dsPIC33CK512MP608 Family Silicon Errata and Data Sheet Clarification

The dsPIC33CK512MP608 family devices that you have received conform functionally to the current Device Data Sheet (DS70005452C), except for the anomalies described in this document.

The following typographic corrections and clarifications are to be noted for the latest version of the device data sheet (DS70005452C):

11. Module: Product Identification System

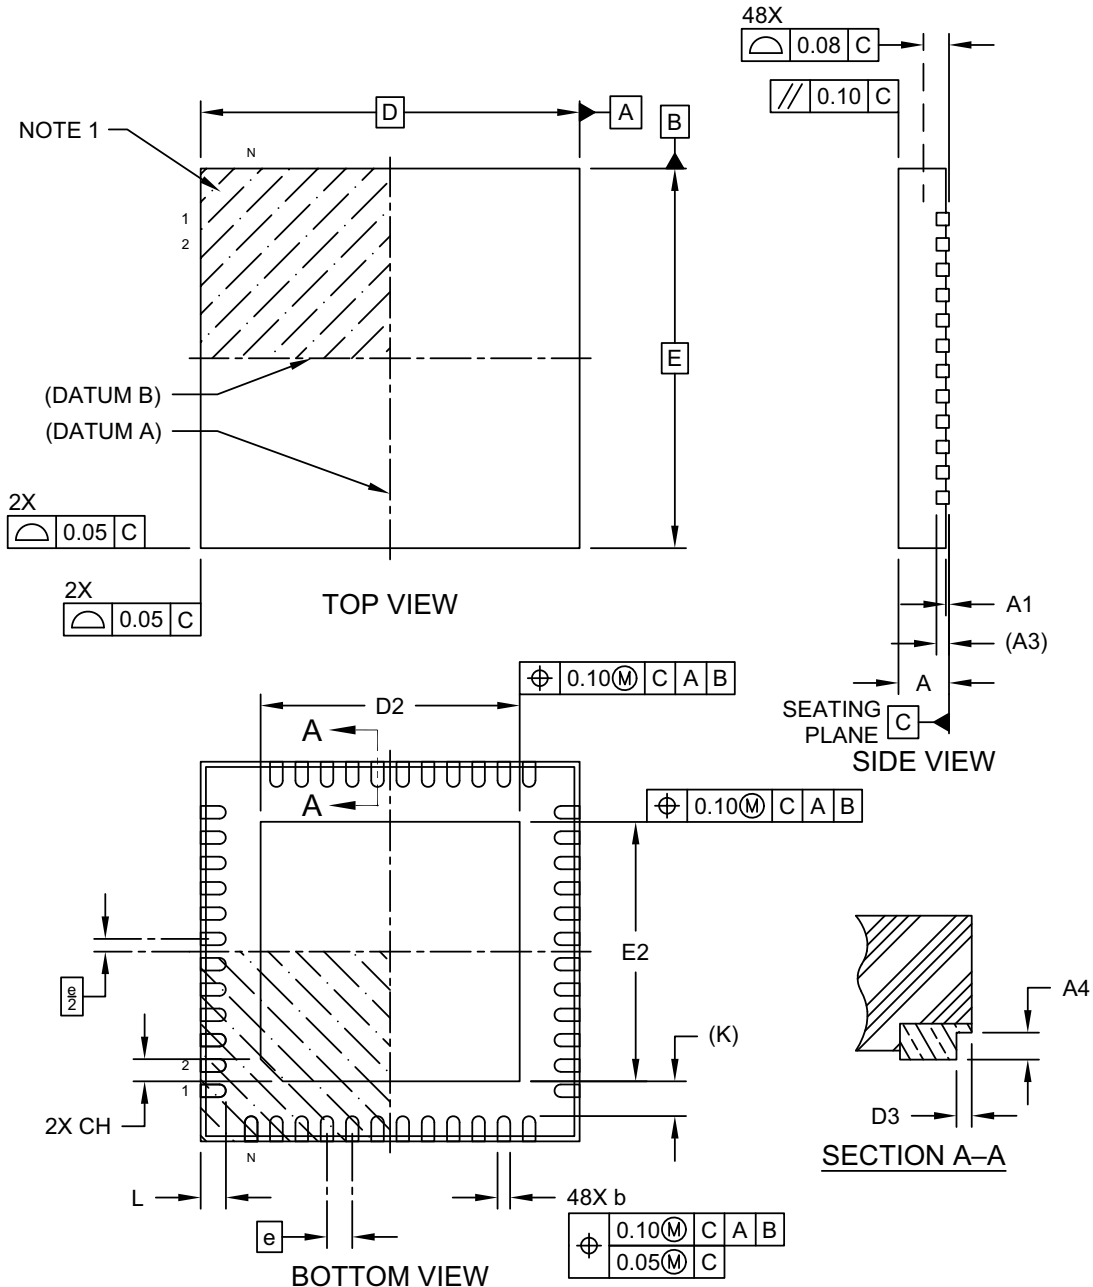
In the Product Identification System, the 6MX package has been changed to M7.

Microchip Technology Drawing C04-504-M7 Rev B Sheet 2 of 2

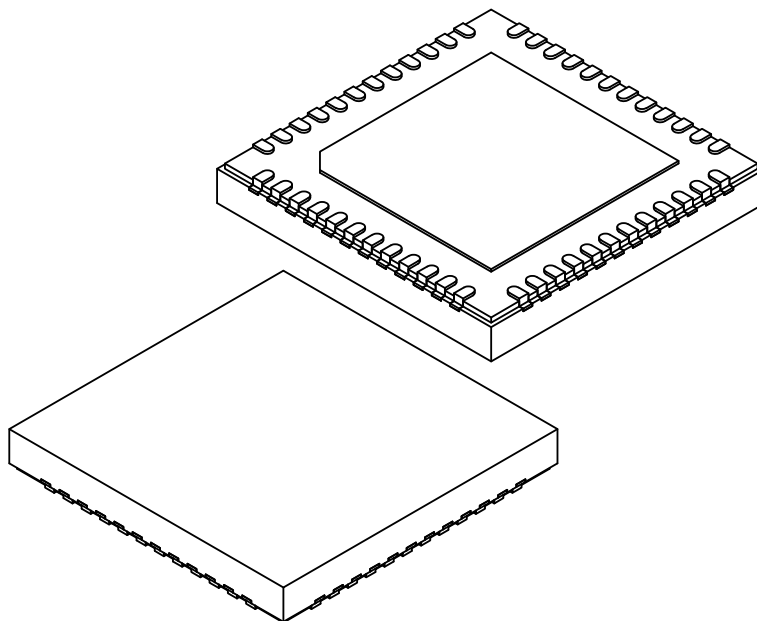
In Packaging Information, the 6MX drawings have been replaced with M7 drawings as shown below.
